**San Jacinto River Waste Pits Superfund Site  
National Remedy Review Board  
EPA Region 6 Responses to Board Comments  
May 27, 2016**

Figure 3-4  
Spatial Distribution of Predicted Net Sedimentation Rate for  
21-Year Period: Pre-TCRA Base Case Simulation  
Feasibility Study  
San Jacinto River Waste Pits Superfund Site

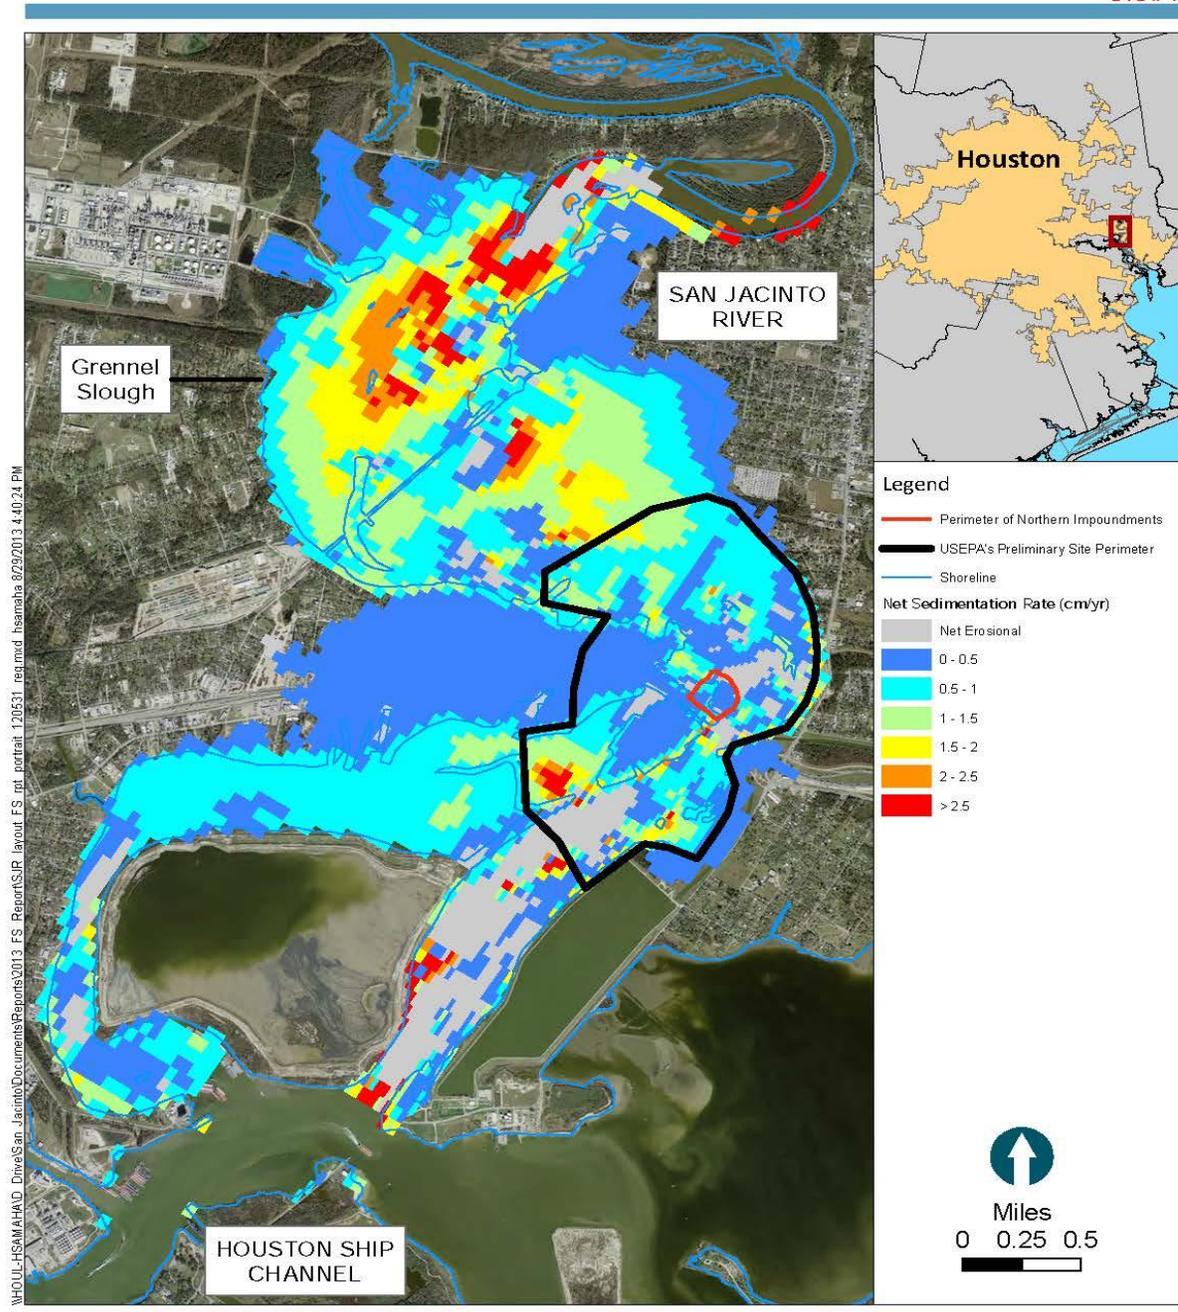
12. MNR – In the package presented to the Board, MNR is being considered to address contamination in the aquatic environment in North of I-10 alternatives 2-5 but it does not appear from the package that the Region has evaluated the effectiveness of MNR to demonstrate that it is likely to reach the remediation goals identified. Given the effects of storms on sediments, it is unclear whether MNR (either through dilution or covering with cleaner sediments) can be relied upon as a component of the remedy. The Board recommends that the Region include in the decision documents information on where MNR may

be used and based on aquatic conditions (deposition, erosion) an evaluation on whether this technology will enhance protectiveness and be permanent in the future.

Spatial distributions of predicted net sedimentation rates (NSRs) for the long-term simulation period for pre- (i.e., the sediment transport model calibration) and post-TCRA conditions as shown on Figures 3-4 and 3-5 (Appendix A of the FS), respectively are shown below.
